Drain: PEBBLE BROOK DRAIN **Drain #:** 191
Improvement/Arm: VILLAGES AT PEBBLE BROOK - SECTION 1
Operator: JDH **Date:** 2-26-04
Drain Classification: Urban/Rural **Year Installed:** 1992

Drain-Improvement: PEBBLE BROOK DRAIN - VILLAGES AT PEBBLE BROOK - SECTION 1

**Re: Pebble Brook Drain - Villages at
Pebble Brook Sec. 1 arm**

CONSTRUCTION PLANS FOR THE VILLAGES AT PEBBLE BROOK - SECTION I & III

Map Correction-Field Verification

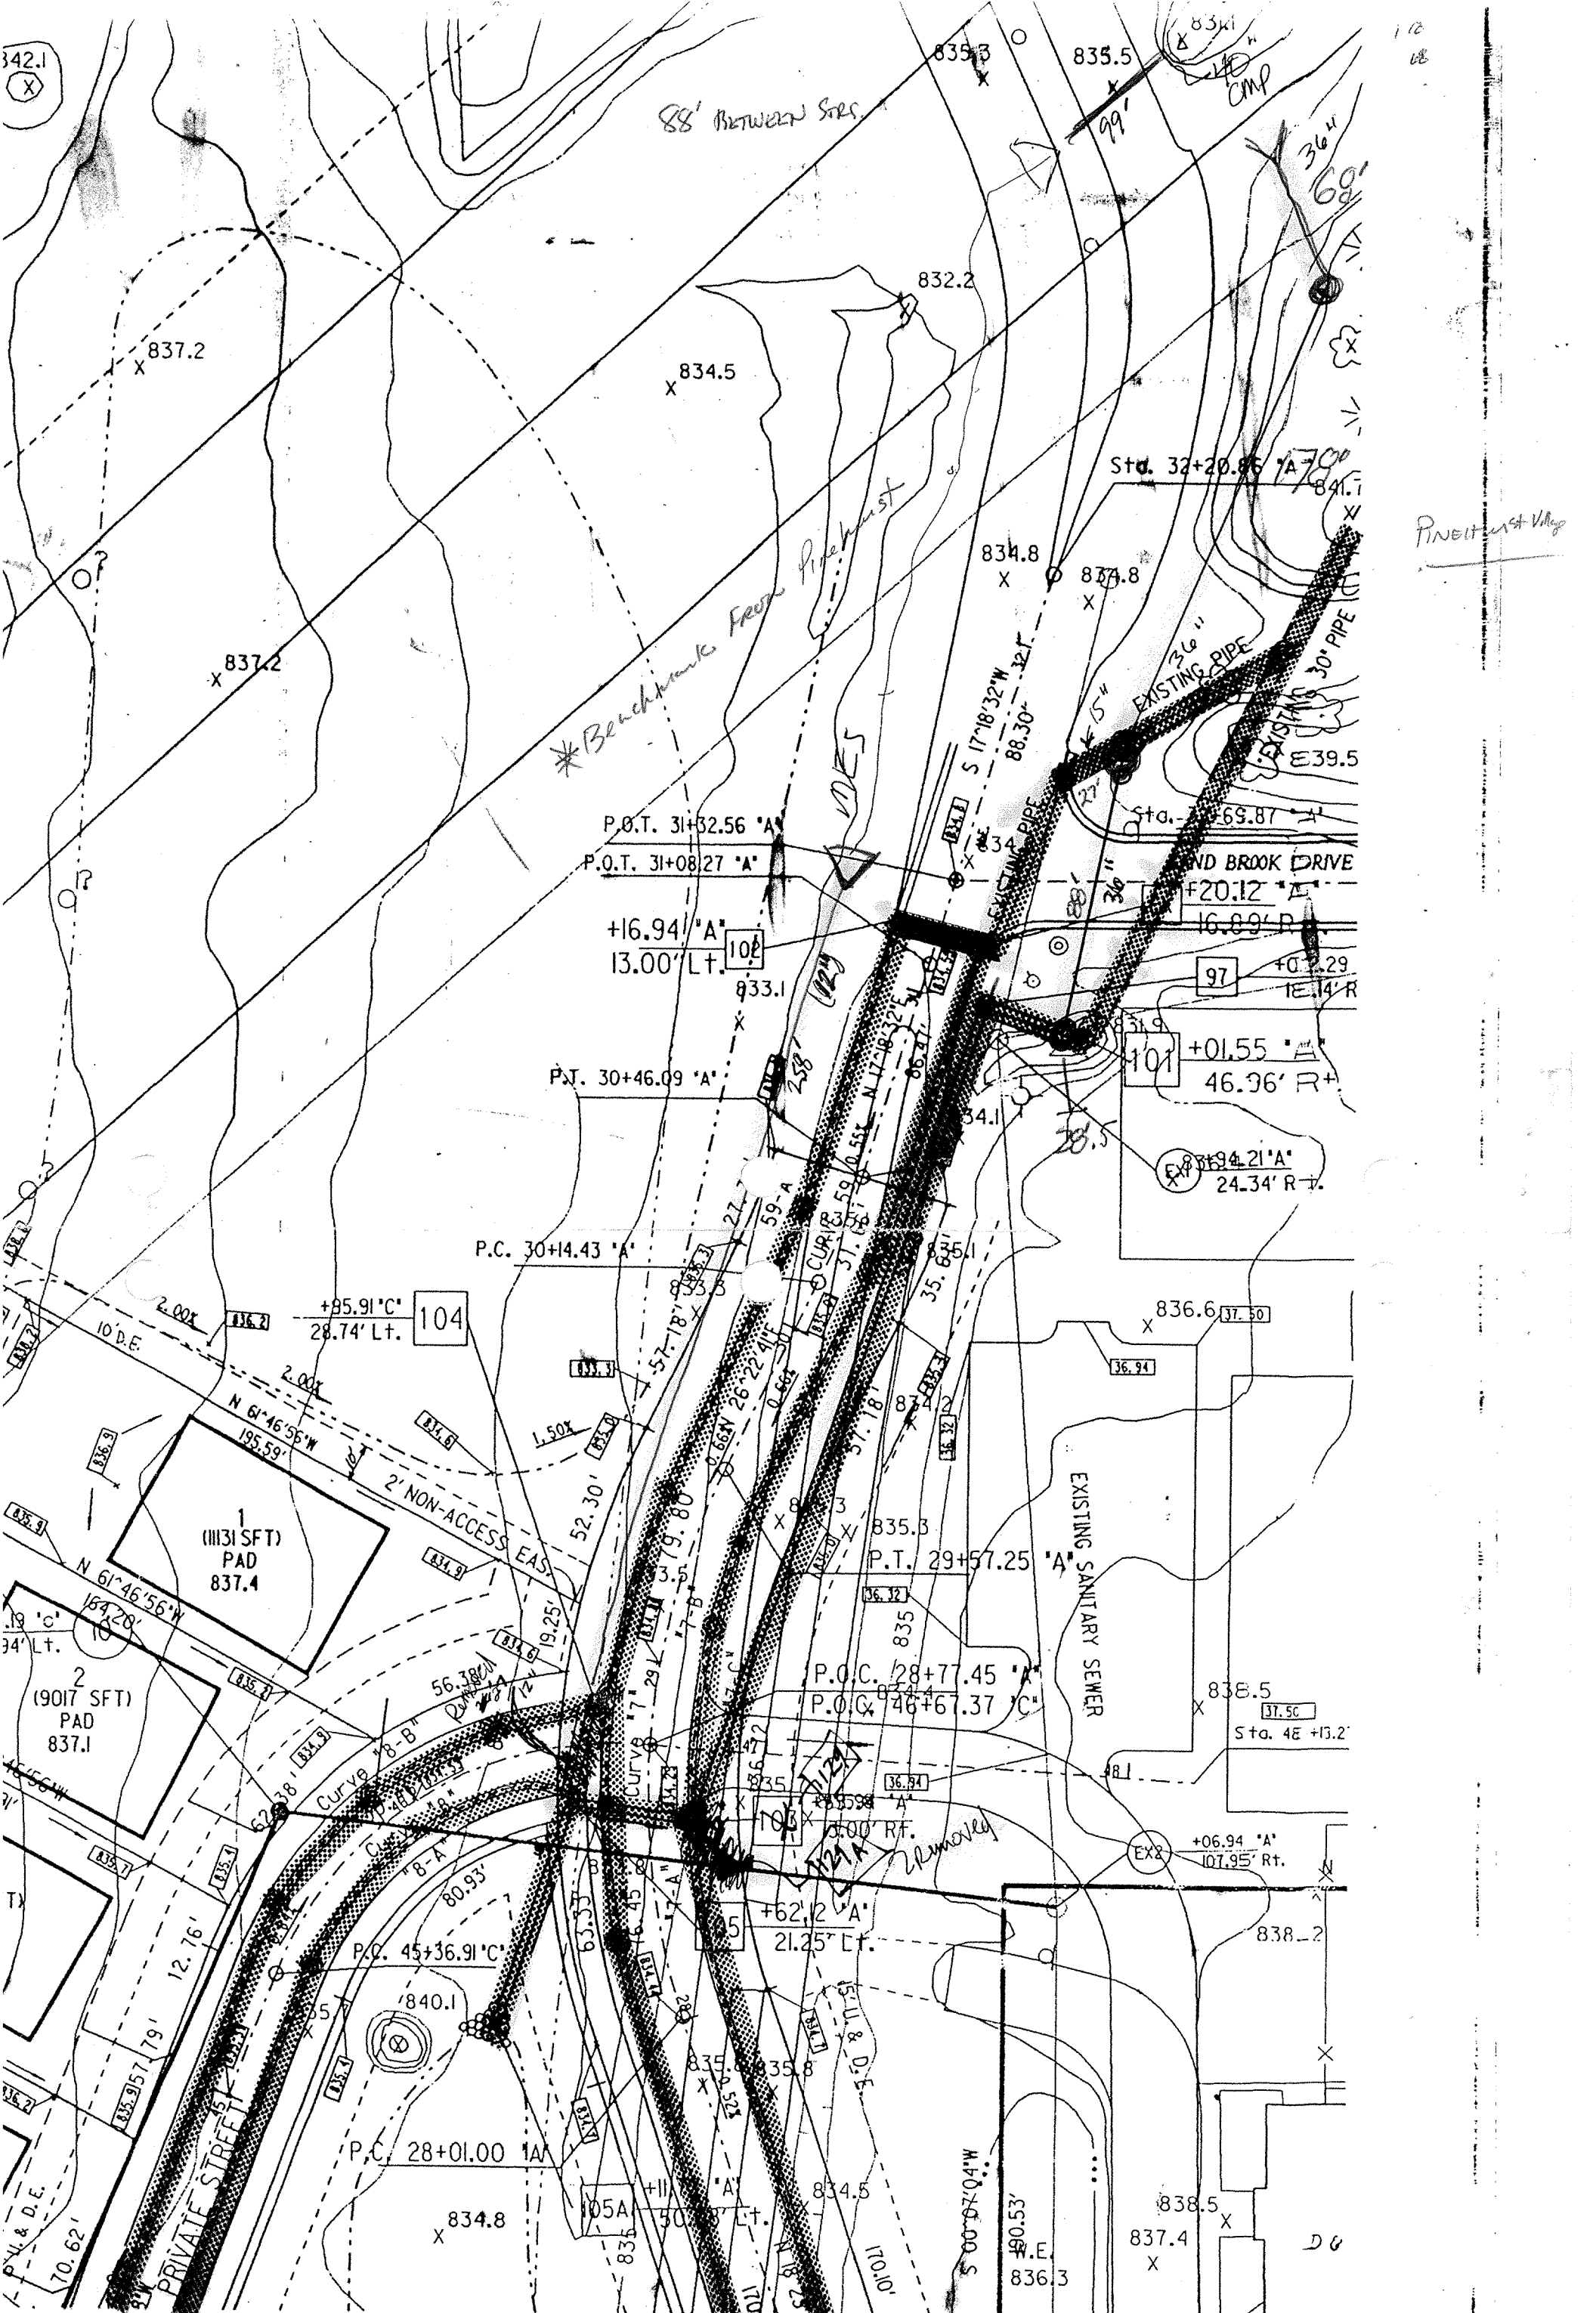
Drain Length: 718'

Change +/-: -45

New Length: 673' (additional)

Title:	DEC 17 1996
SITE DEVELOPMENT PLAN	
Scale: 1" = 40'	Job No: 114-0548
	Sheet No: 7 of 25

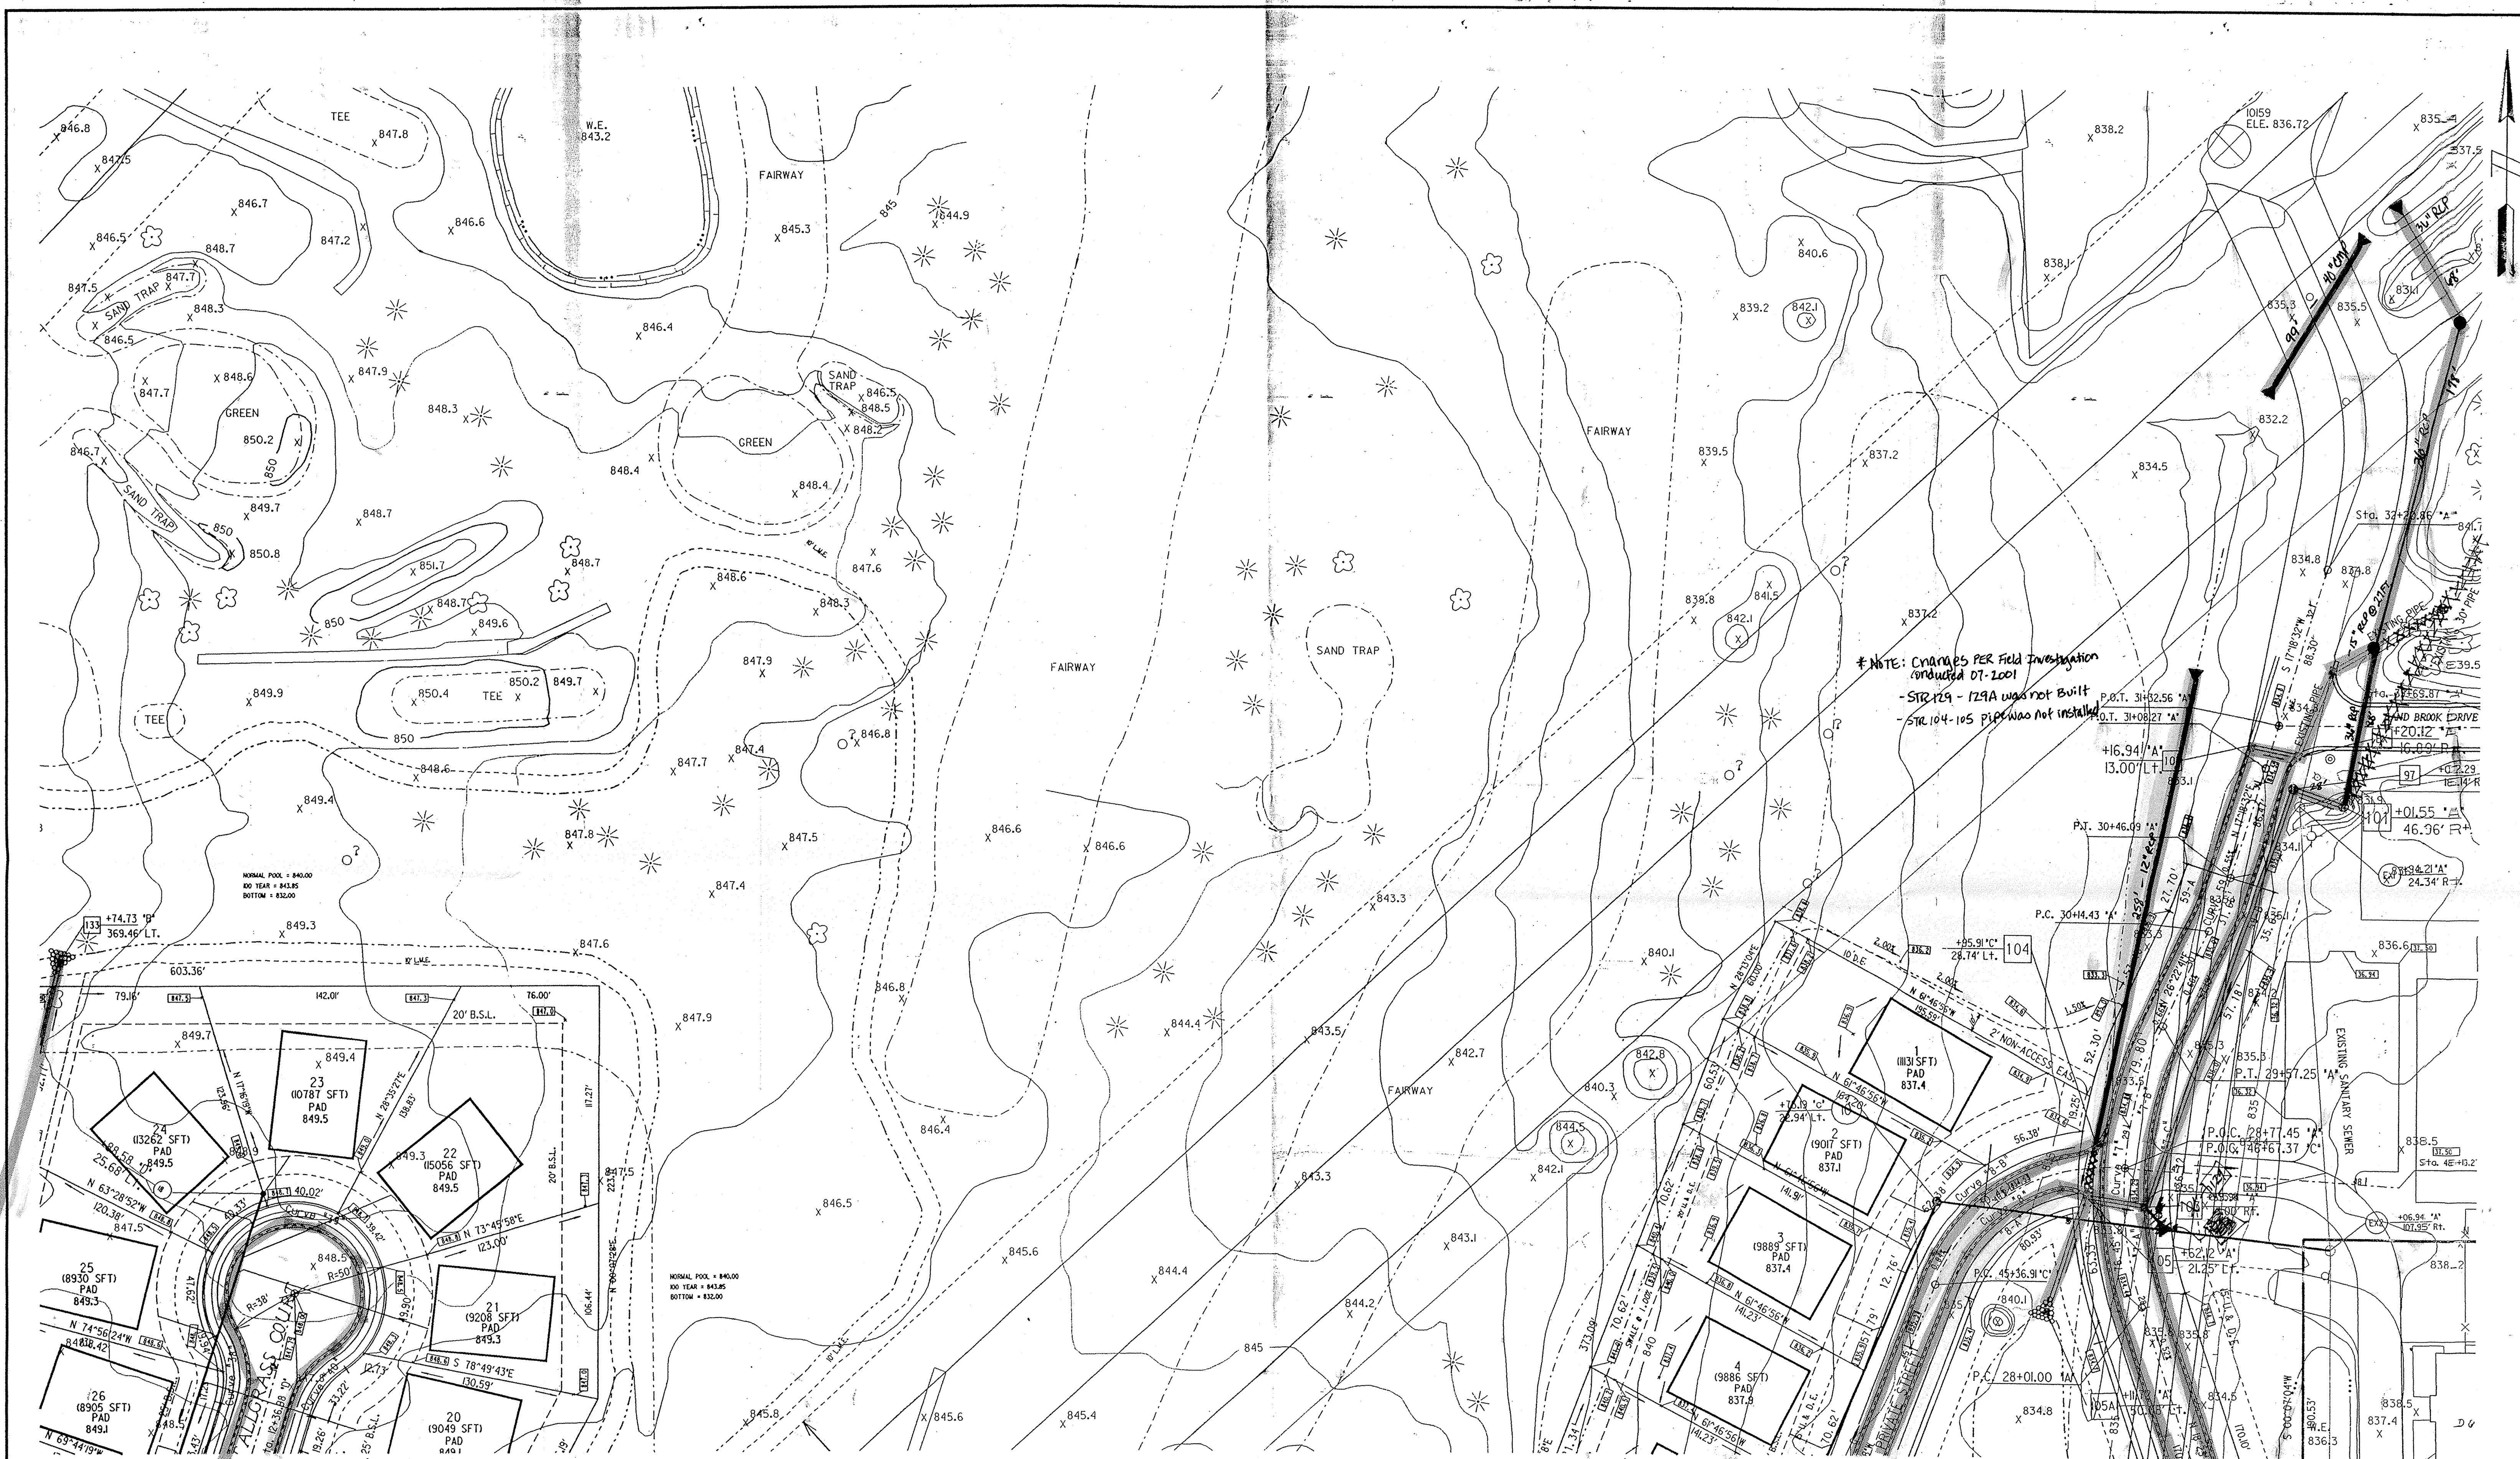
* NOTE: CHANGES PER FIELD INVESTIGATION
 conducted 07-2001
 - STR 129 - 129A was not built
 - STR 104-105 pipe was not installed
